寄件者: WARREN WONG [REDACTED]
寄件日期: 2026年07月13日星期一 15:26
收件者: Esther Hiu Laam LI/PLAND
副本: Shirley Ka Kei CHAN/PLAND [REDACTED]
主旨: FI for Department Comment of S16# A/NE-FTA/281
附件: Departmental comments Response (DLO North) - FTA 281.pdf; Departmental comments Response (PlanD) - FTA 281.pdf; Departmental comments Response (TD) - FTA 281.pdf

Response to the comments of Transport Department (as at 30 June, 2026)

擬議臨時貨倉及露天存放建築材料連附屬設施及相關的填土工程 (為期3年)

項目:新界打鼓嶺丈量約份第87約地段第360A號A分段(部分)、第360A號餘段(部分)、第360B號A分段(部分)、第360B號餘段(部分)、第360C號餘段(部分)、第360C號A分段(部分)、第360D號A分段(部分)及第360D號餘段(部分)和毗連政府土地 擬議臨時貨倉及露天存放建築材料連附屬設施及相關的填土工程 (為期 3 年)	圖目: 車輛(私家車) 行駛示意圖 (由申請場地駛出往 坪輦路方向)	圖號: 圖 11
		比例: 1:500

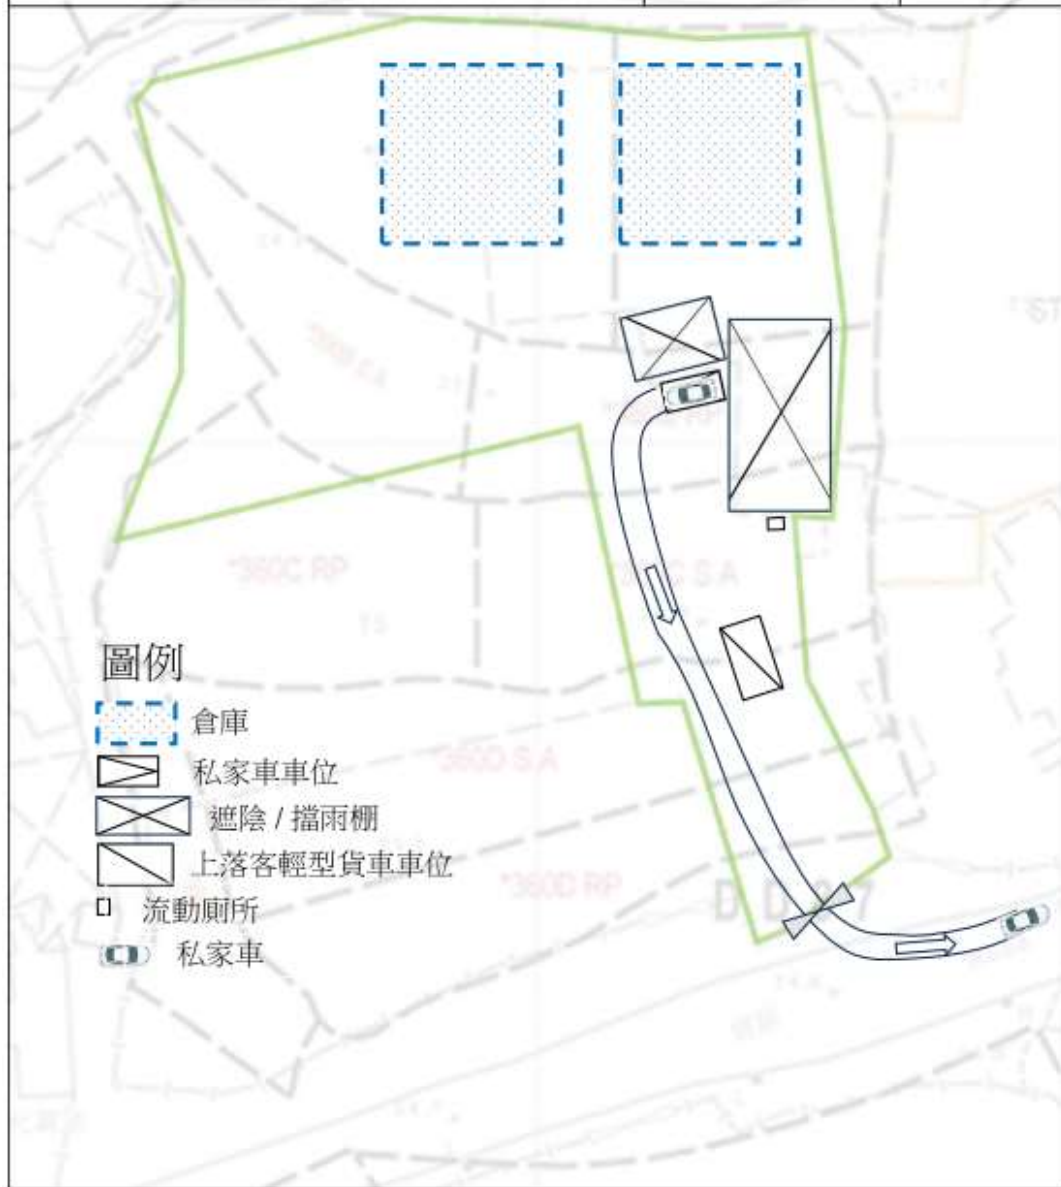
1. The applicant shall demonstrate the satisfactory maneuvering of the private car within the application site (the Site) and into/out of the parking, preferably using the swept path analysis:

知悉。有關私家車的車輛行車線分析圖已新增。見下圖 10, 11, 12, 13。

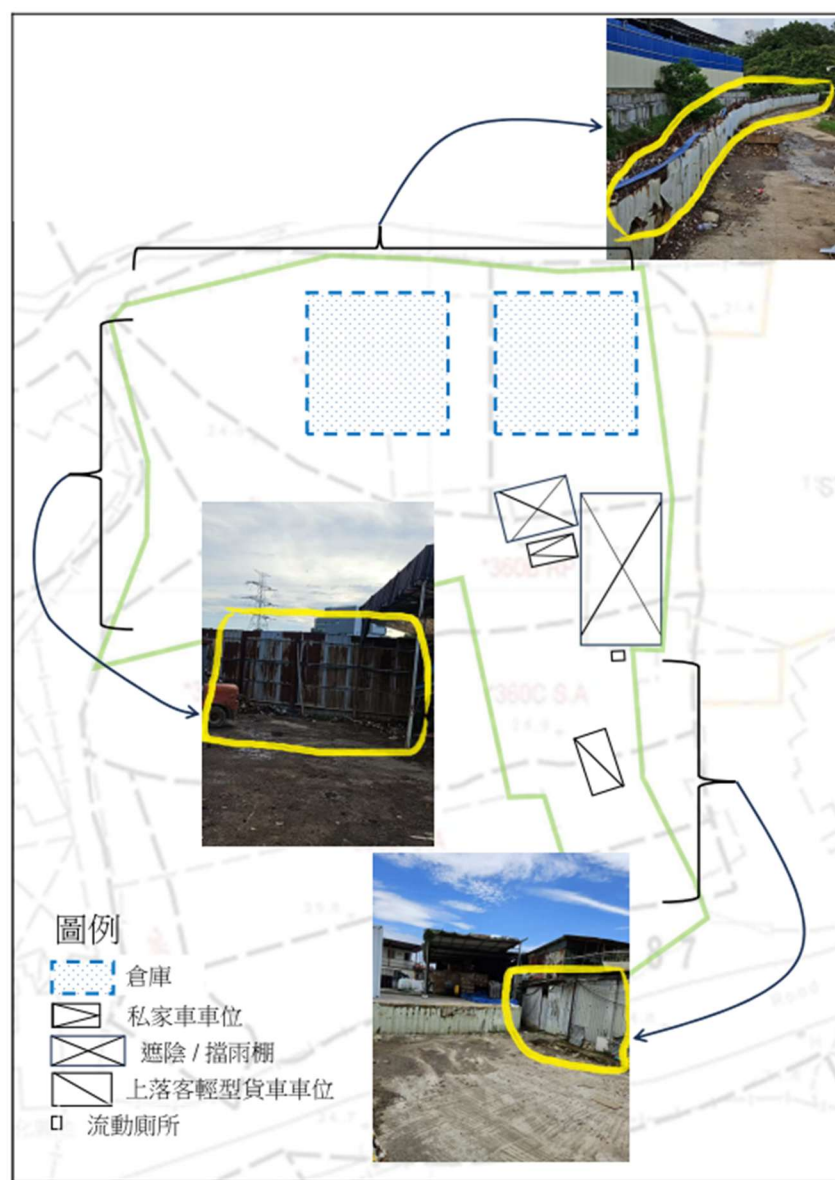
3. Please advise if any fencing will be erected along the site boundary on all sides. If so, please provide details on the material and height of the fencing.

基於安全，現時在場內周邊是有圍板設置的。高度約 1 米至 3 米不等，材料均為耐火、不助燃鐵板。大概位置及範圍可參考附圖。
